Request for Quotation

RFQ NUMBER
PTR12029

LINE	QUANTITY	UOP	CAT. NO.	ITEM NUMBER	UNIT PRICE	AMOUNT
ADDENDUM NO. 1						
ANSWER TO TECHNICAL QUESTIONS ATTACHED.						
BID OPENING DATE AND TIME REMAINS 05/03/12 @1:30 P.M.						
NO OTHER CHANGES.						
0001	1	EA		863-05		
18 PASSENGER CUTAWAY WITH A/C, WHEELCHAIR LIFT AND						
***** THIS IS THE END OF RFQ PTR12029 ***** TOTAL: _____

PTR12029 Approved Equals
April 2nd, 2012

FORD REAR LIFT

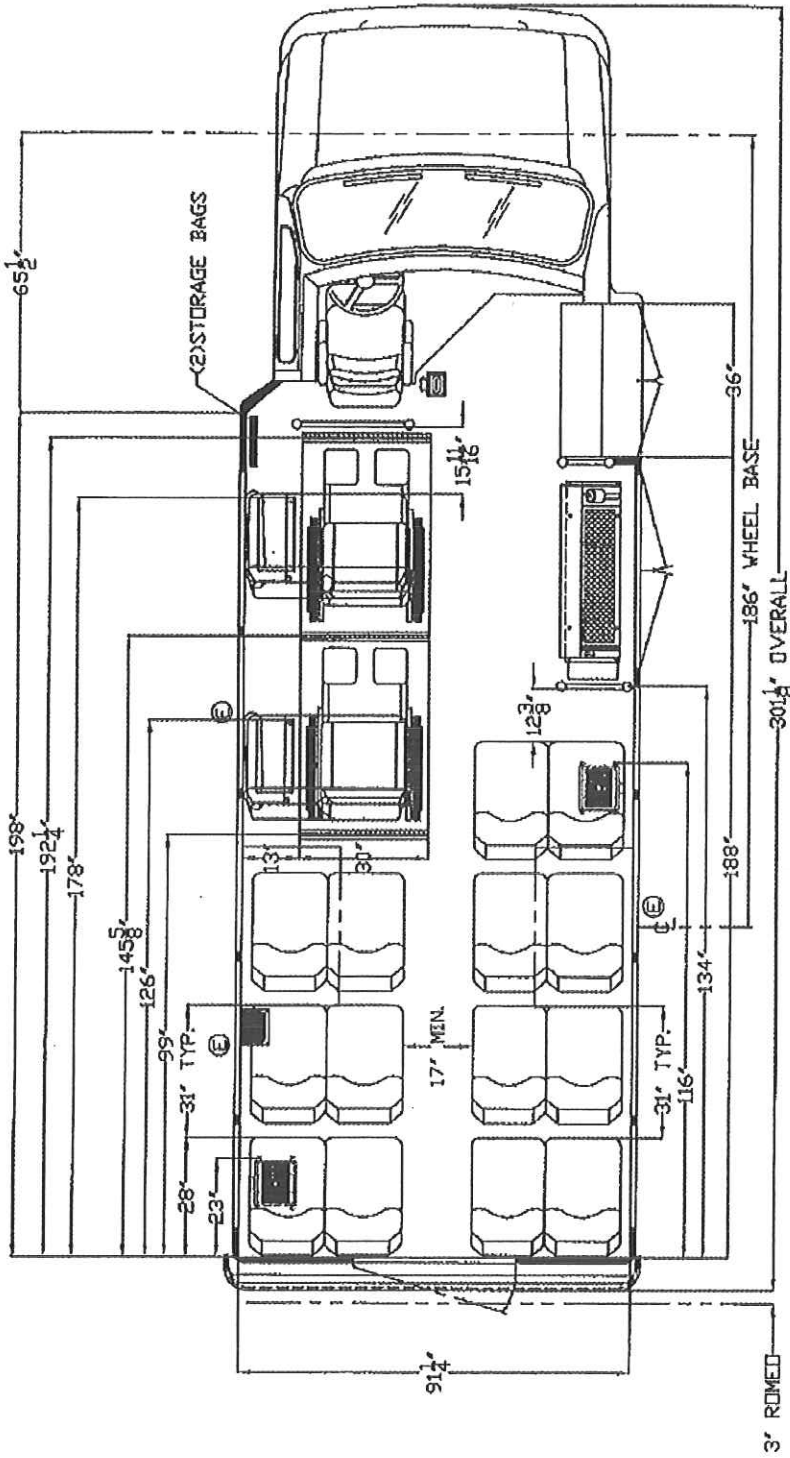
passenger Entrance/Exit	the spec states that the lift doors are to be located behind the rear wheels but the plan provided on page 68 shows the lift in front of the rear wheels. Which is correct?	Ford Rear Lift floor plan with the rear W/C door.

and receive parts promptly from the closest listed parts facility.	warranty service is to be provided to four (4) areas of West Virginia is to be included in the bid proposal.
		Floorplan	Could the Division of Public Transit provide a rear lift floorplan similar to the front lift version provided at page 71?	Yes. Please see attached Ford Rear Lift Floor plan.
		Floorplan	Could the Division of Public Transit confirm that the floorplan at page 71 is acceptable for the extended length front lift option?	The Ford Front Lift Floor plan is acceptable for the front lift (option F); the Ford Rear Lift is the floor plan for the basic bus
APPROVED EQUALS

FORD REAR LIFT

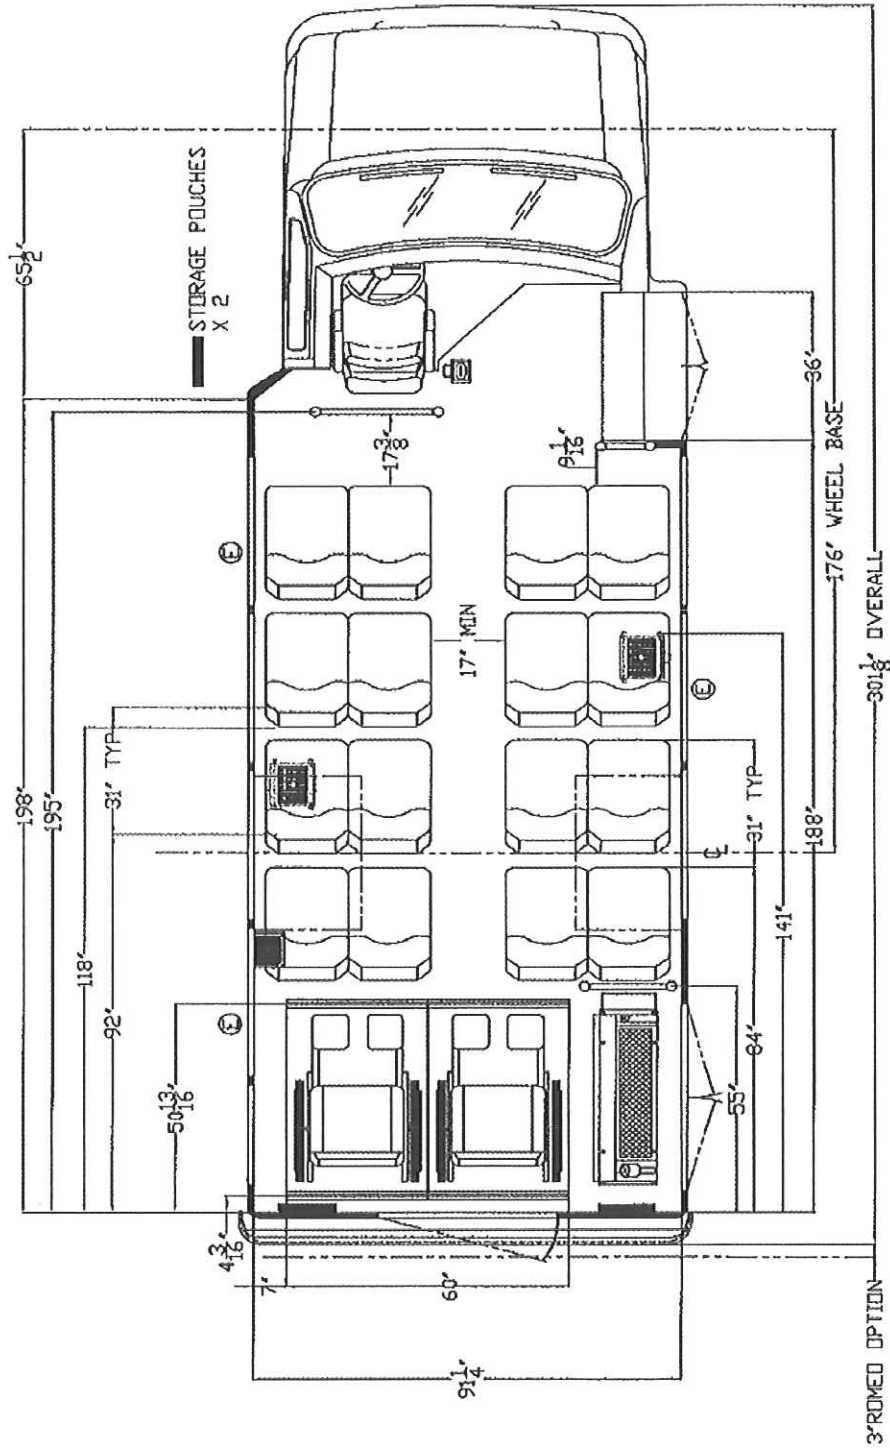
11.3	42	Mobility Aid Securement- Wheelchair spacing	This section asks for the wheelchair positions to be spaced a minimum of 10" apart. The floor plan for the 2-wheelchair bus shows the L-track being spaced 6' apart (center-to-center), which should provide ample spacing. Please accept 6" spacing as shown on the floor plan.	This clarification to the specs is approved.
